BROWNS FERRY NUCLEAR PLANT (BFN) - UNITS 1, 2, AND 3 LICENSE RENEWAL APPLICATION - REACTOR SYSTEMS SECTION 2.3.1, 2.3.2, AND 2.3.3 - REQUEST FOR ADDITIONAL INFORMATION (TAC NOS. MC1704, MC1705, AND MC1706)

RESPONSE TO NRC REQUEST FOR ADDITIONAL INFORMATION (RAI),
RELATED TO REACTOR SYSTEMS SECTION 2.3.1, 2.3.2, AND 2.3.3

Figure 1 - Steam Dryer Hood Configurations

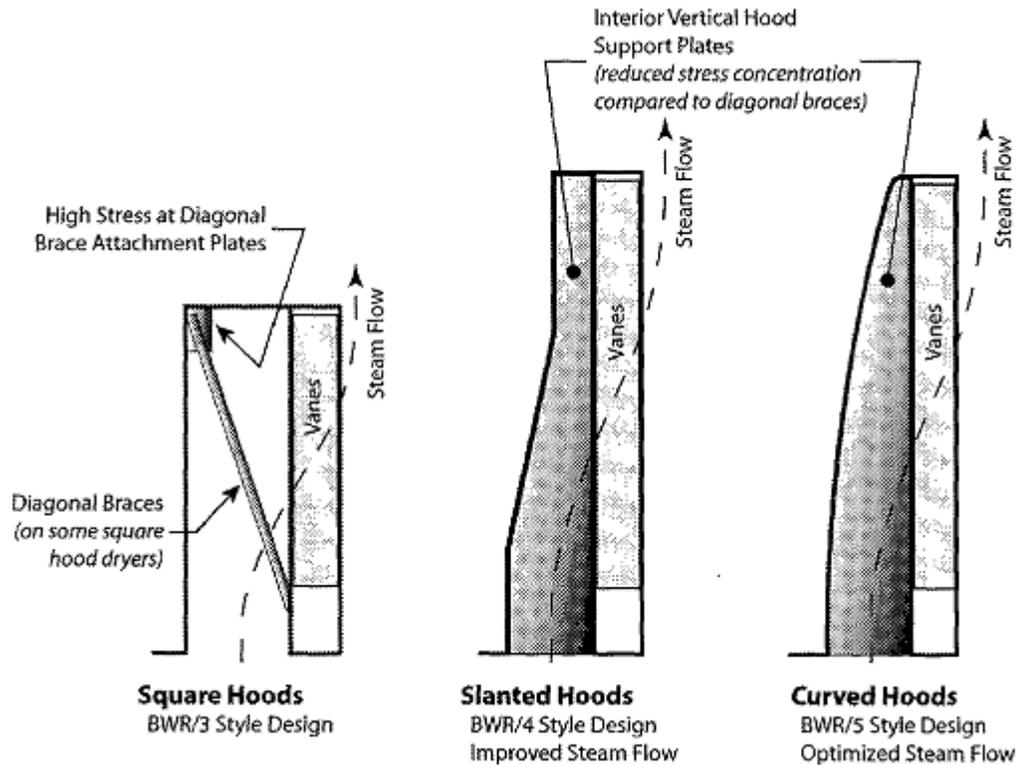
Recent industry experience of steam dryer failures at operating BWRs following power uprate, for example at Quad Cities; and potential to generate loose parts that can degrade safety-related components have necessitated the staff to reconsider whether steam dryer should be within the scope of license renewal, in accordance with 10 CFR 54.4(a)(2), requiring aging management. Although the steam dryer does not perform a safety-related function, the steam dryer must maintain its structural integrity to support emergency core cooling system (ECCS) operation, and also to prevent the occurrence of loose parts in the reactor vessel or steam lines that could adversely affect plant operation. The Interim Staff Guidance (ISG-09), which provides clarification of the 10 CFR 54.4(a)(2) scoping criterion, states that if industry failures of non safety-related SSCs have previously been experienced that may impact safety-related SSCs, then the applicant should include such non safety-related SSCs within the scope of license renewal; or to provide explanation that similar failures are unlikely to occur at the BFN plant following power uprate. The staff, therefore, requests the applicant to include the steam dryers within the scope of license renewal requiring aging management. The

- a) Are the steam dryer designs at BFN and Quad Cities similar? If not, please describe the significant differences between the two designs which support the conclusion that steam dryer failure similar to Quad Cities are unlikely to develop at the BFN steam dryers following power uprate.
- b) Describe any actions, including analysis that will be performed to confirm whether extended power uprate conditions will either generate, or not generate loose parts from the steam dryer.

The steam dryers have been added within the scope of license renewal for 10 CFR 54.4(a)(2) scoping criterion.

- a) There are three general types of steam dryer configurations see Figure 1):
 - 1. BWR/3-style steam dryers with a square hood and internal braces (NOTE: This is the configuration of the steam dryers at Quad Cities).
 - 2. BWR/4-style steam dryers that have slanted hoods (NOTE: This is the configuration of the steam dryers at BFN).
 - 3. BWR/5 and later steam dryer designs that incorporate curved hoods to optimize the steam flow.

The BFN dryers are not the same design as the dryers at Quad Cities. Basically the BFN dryer is a slanted hood design which is less susceptible to vibration induced failures than the square hood Quad Cities dryers. GE has conducted finite element model analysis which documents that the square hood is more susceptible to operating stresses.
